## 2.0 Design of Fourth and Fifth floor façades

### 3.0 General Amendments

Proposed Design — North Elevation GMP Façade Study

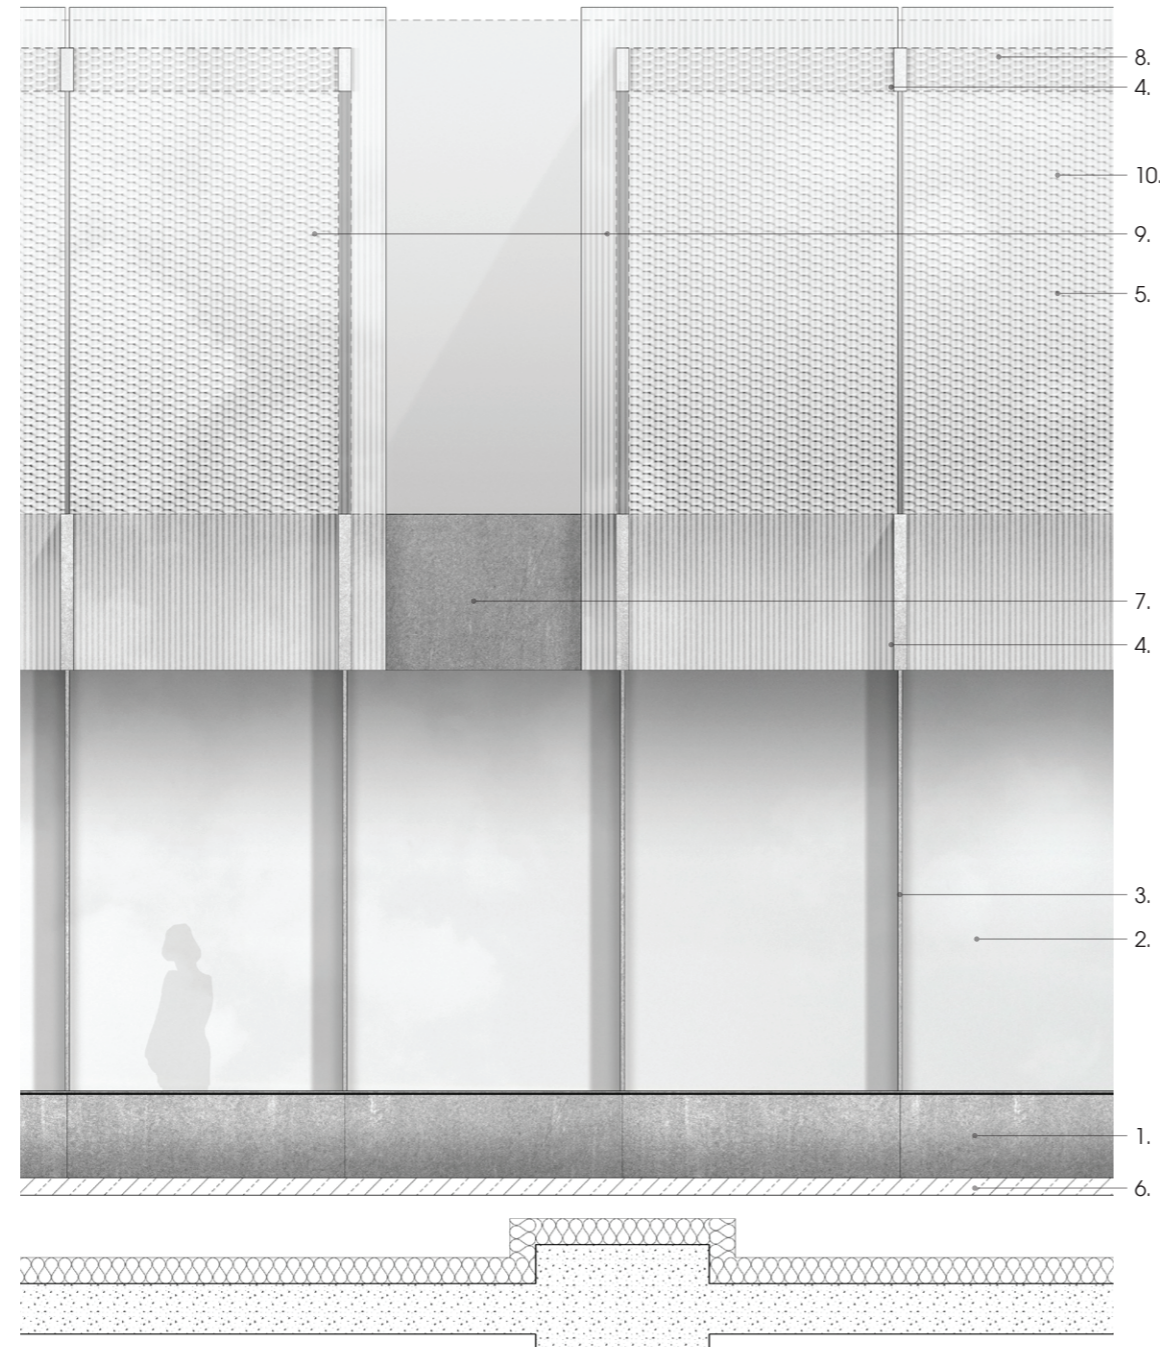
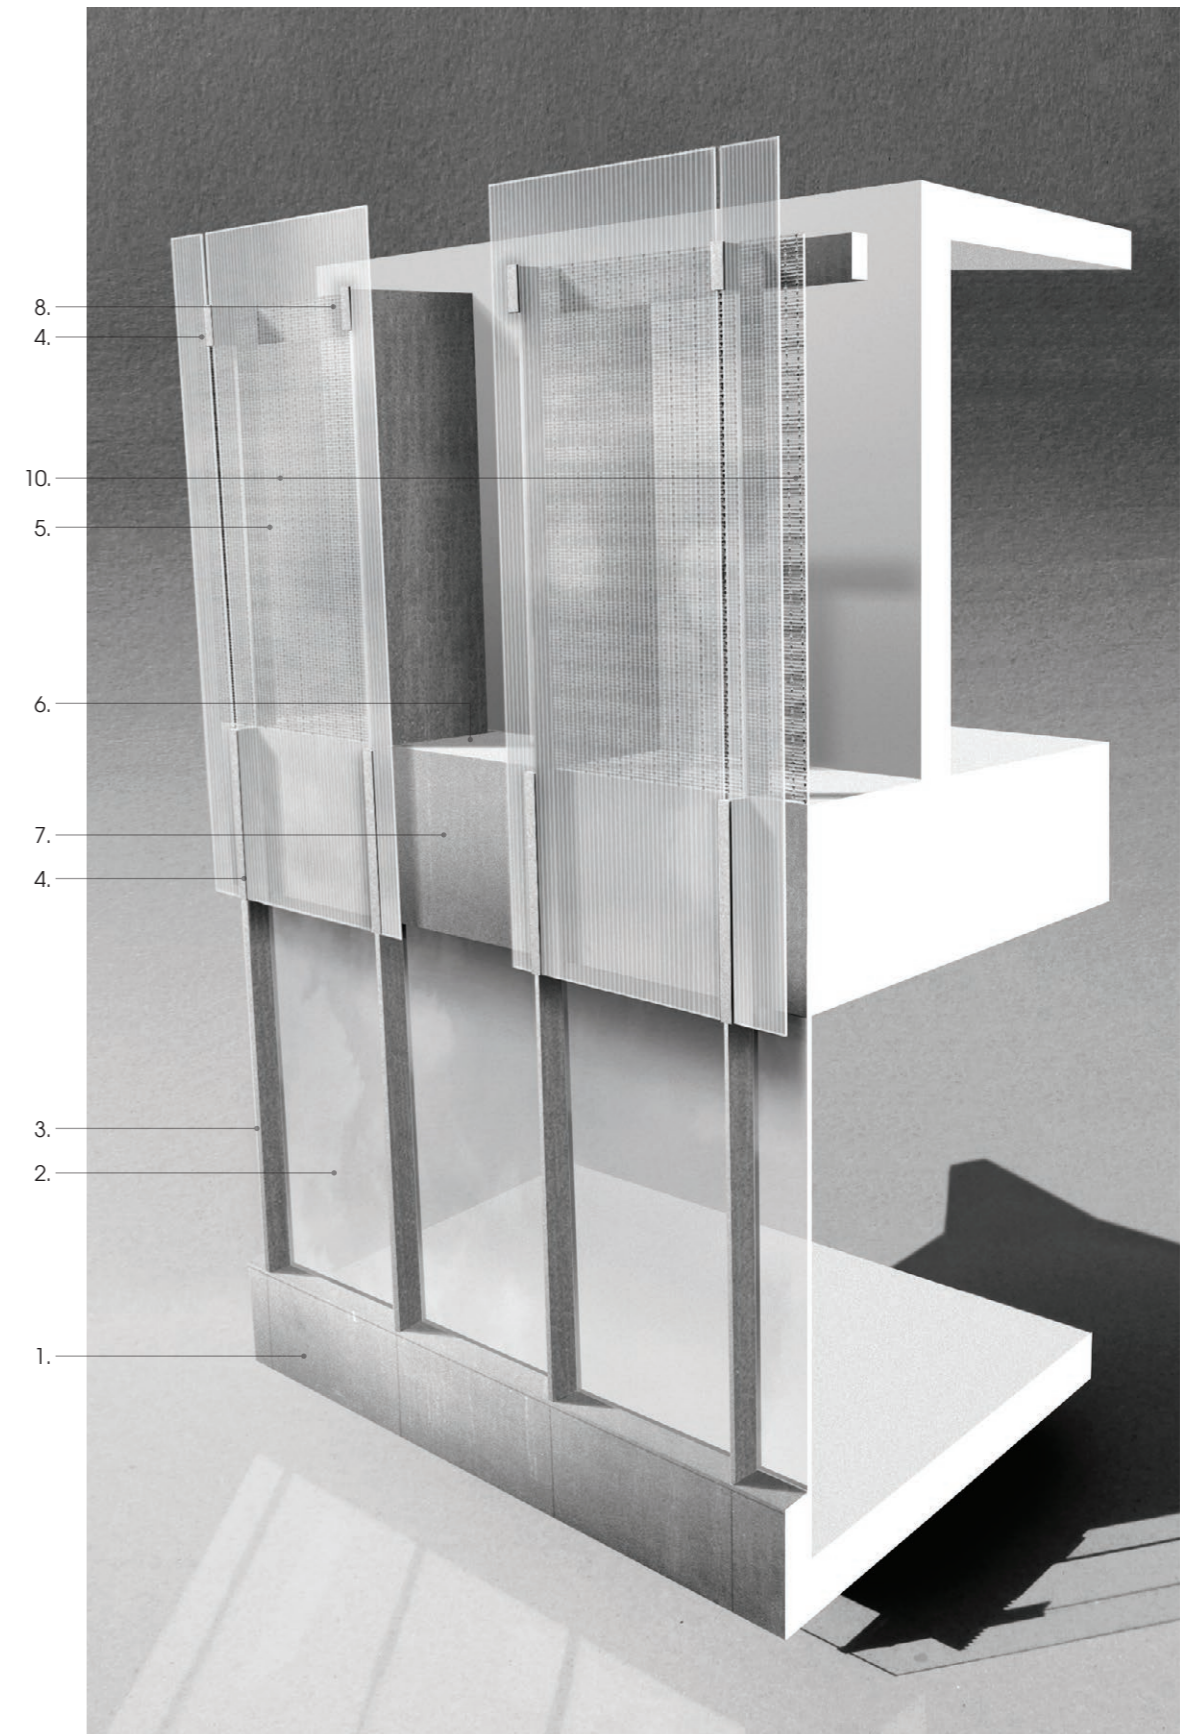
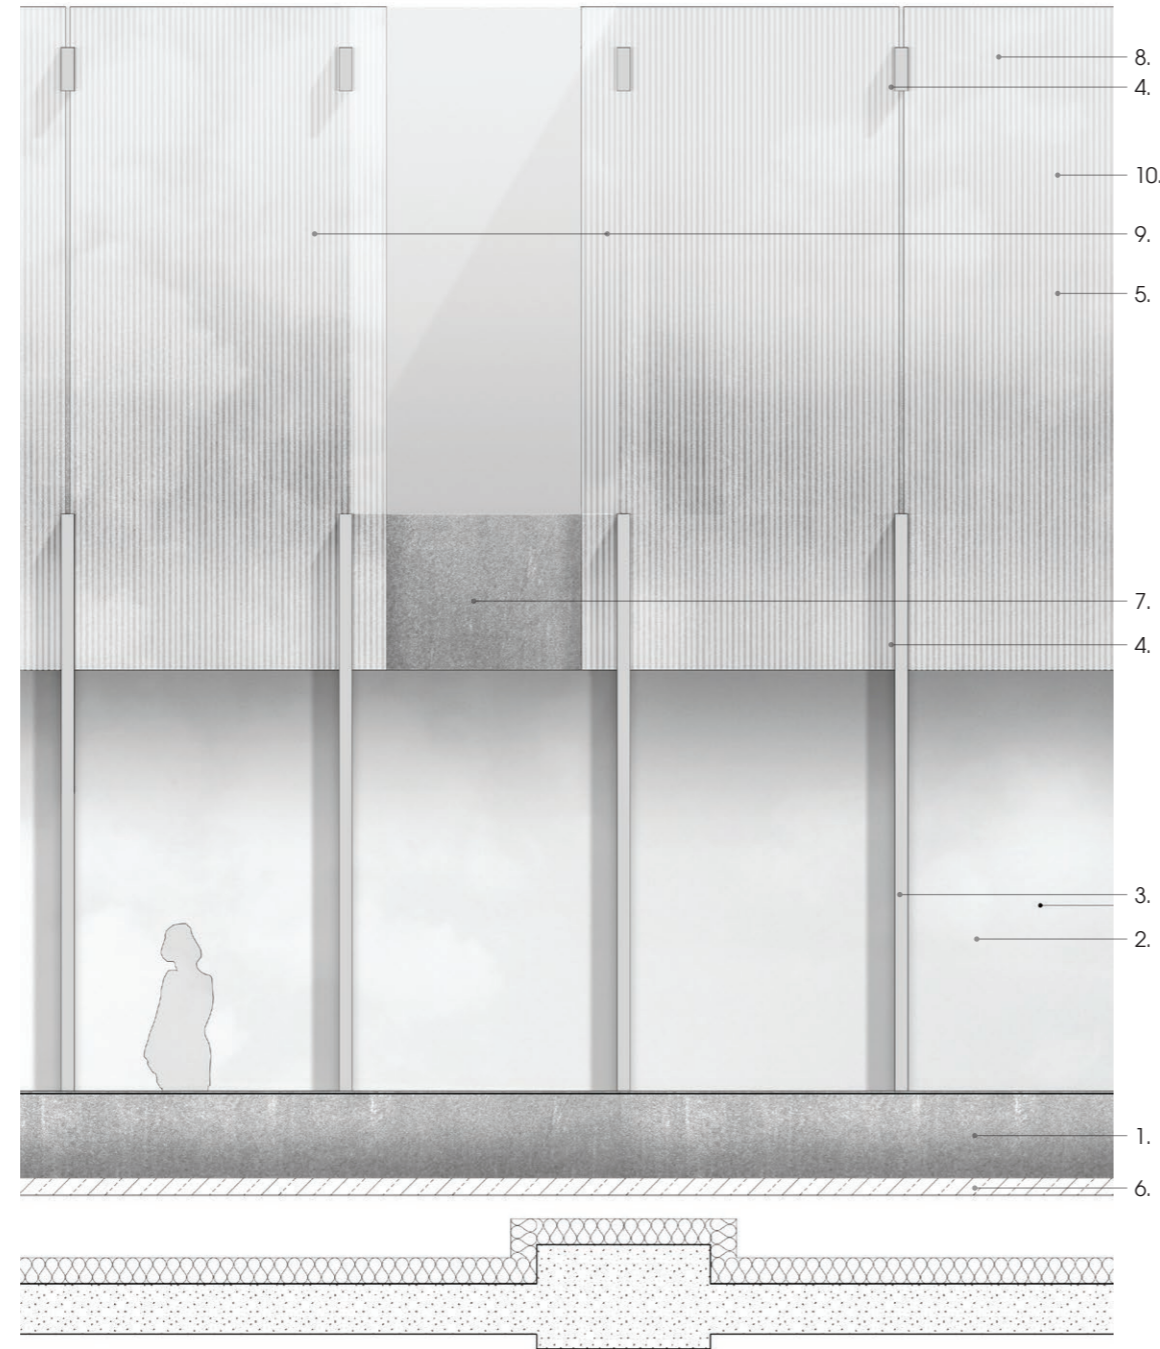
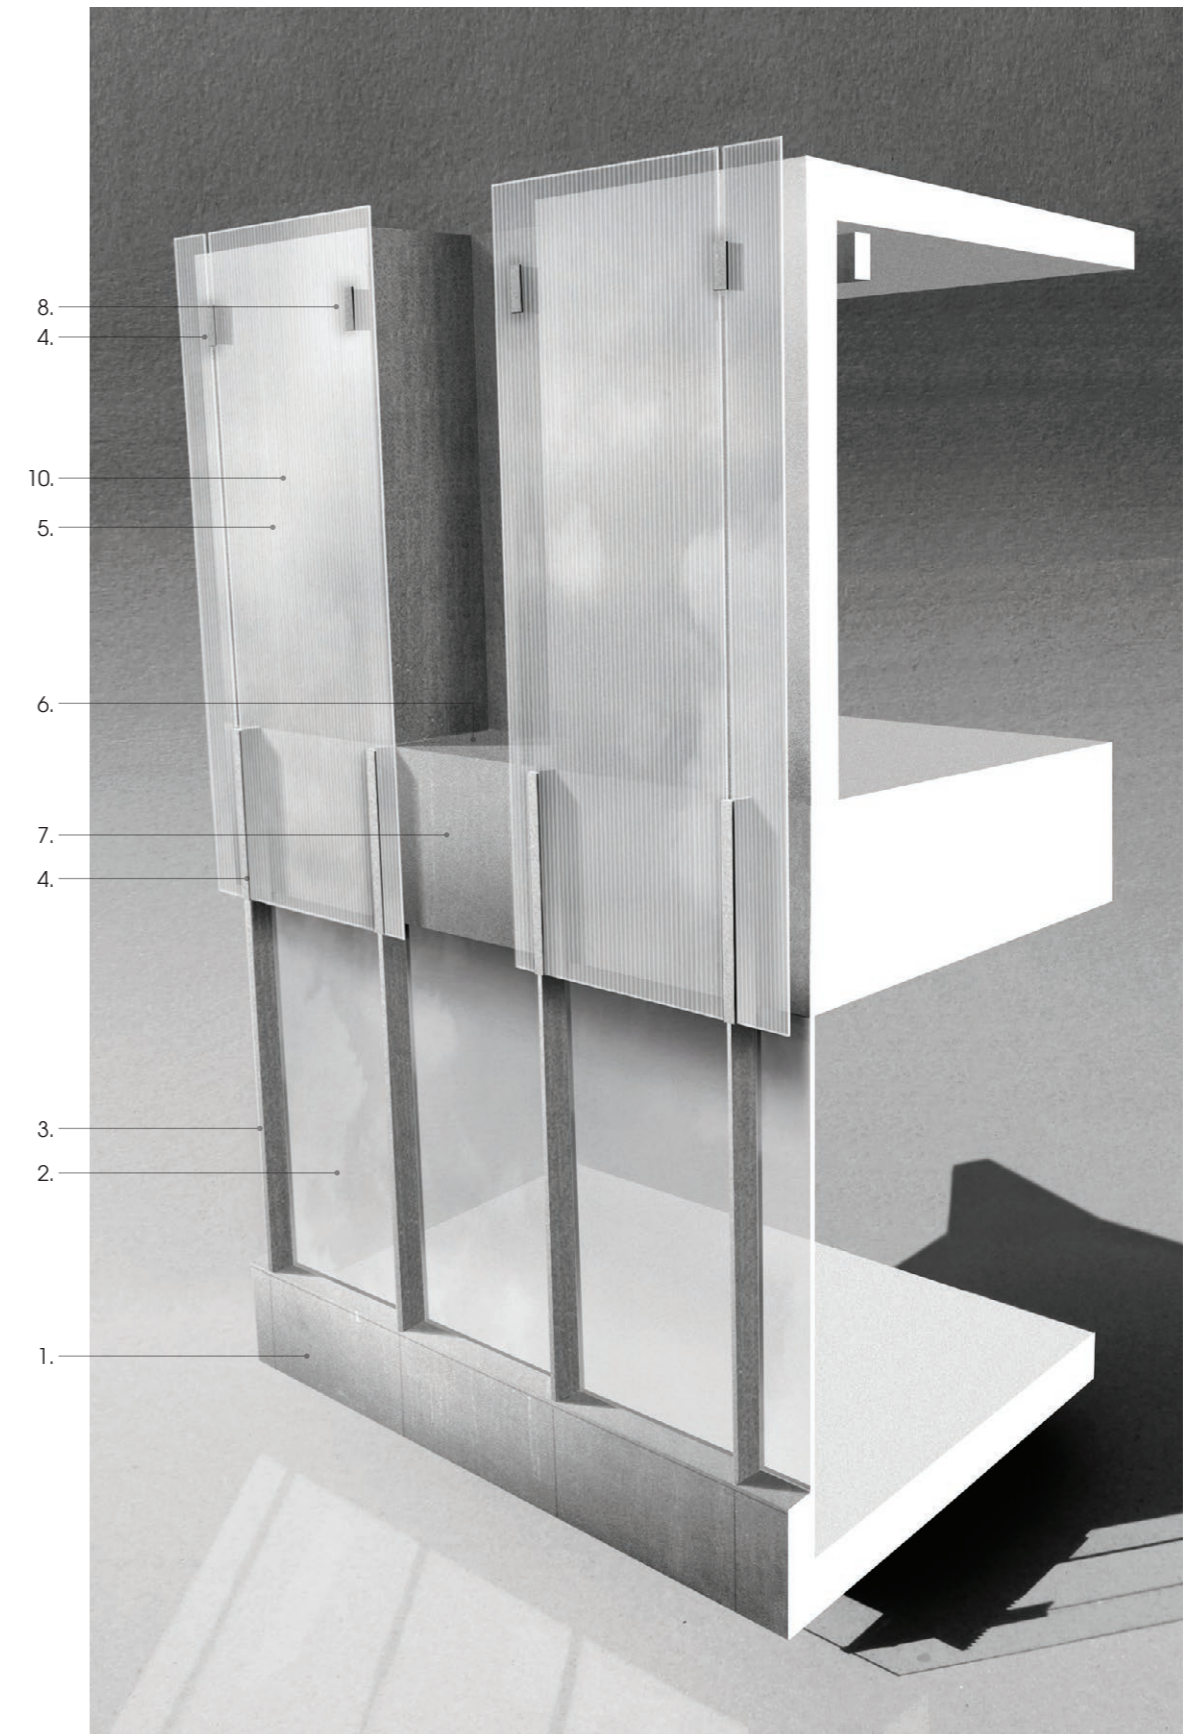
Overall, the design intent for the GMP volume will be the same as the approved scheme. On the fourth floor the setback glazing to the occupied research areas will be framed by deep metal mullions. As in the original design, the glass screen on the fifth floor will overlap the fourth floor glazing with the resulting overhang creating a glass 'veiled' façade on the top (fifth) floor.

Approved Design - North elevation

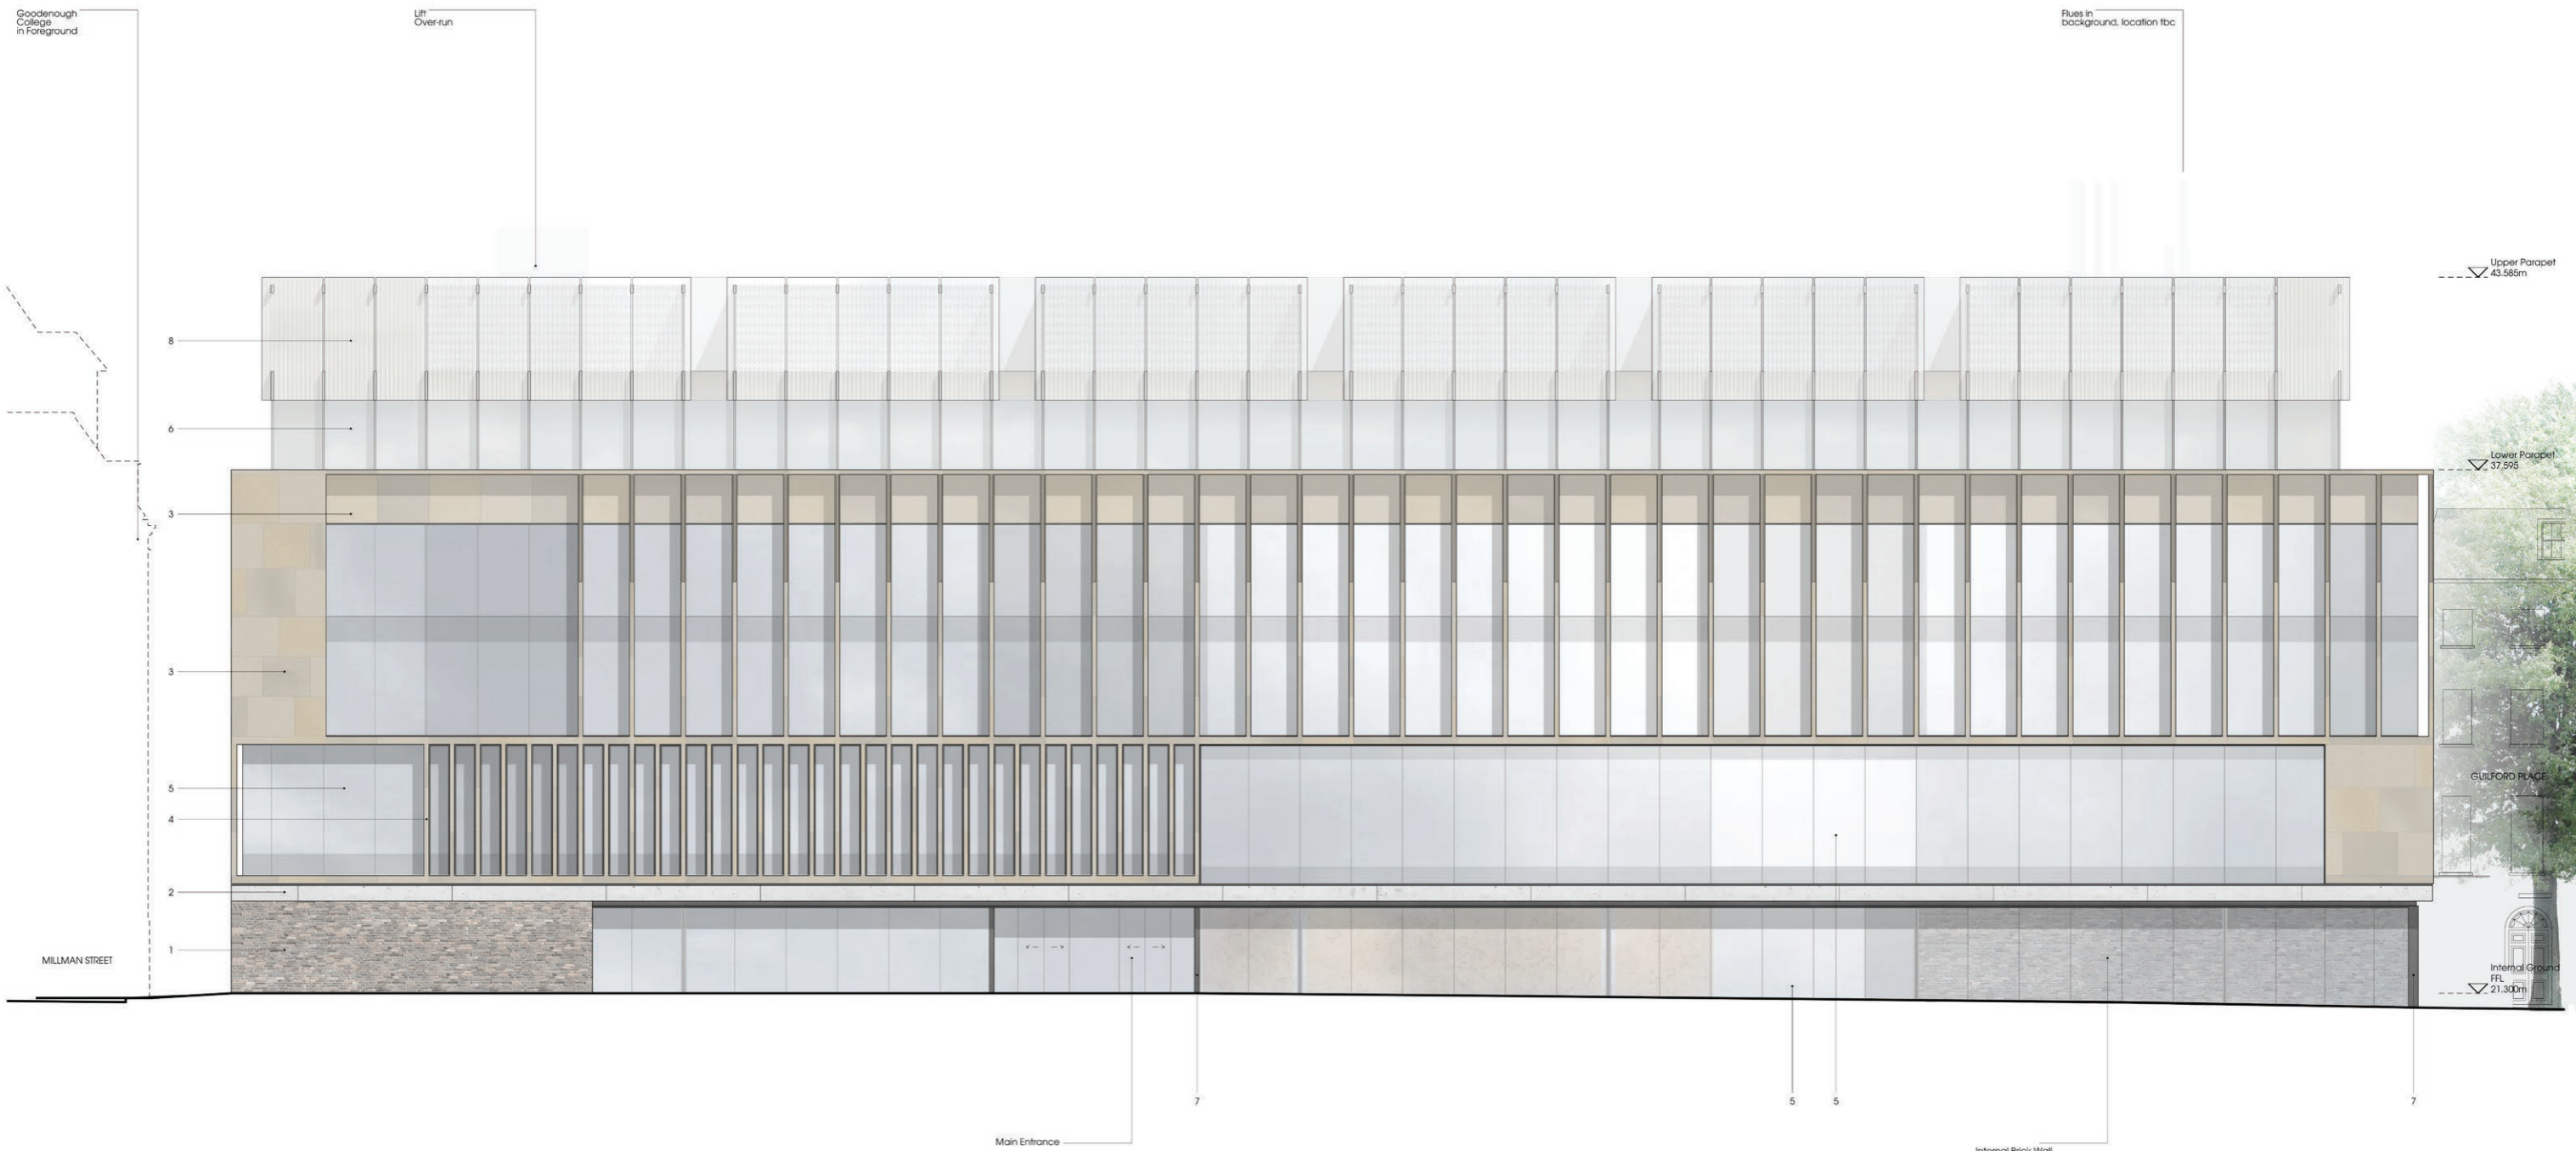
- The use of GRC cladding in lieu of precast at high level ground floor. Colour/texture will be matched with original intentions.
- It is proposed that the ground floor brickwork is to be in stretcher bond, not English bond.
- The building has been coordinated to brick dimensions and therefore there are minor adjustment to glazing sizes.
- The lift overrun on Core 1 (on the northwest corner of the building) has increased in width/length, but reduced in height.
- 4no. ventilation fans have been added to the roof, projecting 475mm above the roof level. These will not be visible from street level.
- Internal brickwork in the laboratory has been omitted
- Amendments to areas of ventilation grilles to accommodate ventilation requirements
- Minor amendments to glazing

Further, particular changes to each elevation are highlighted on the proposed drawings in the following pages.
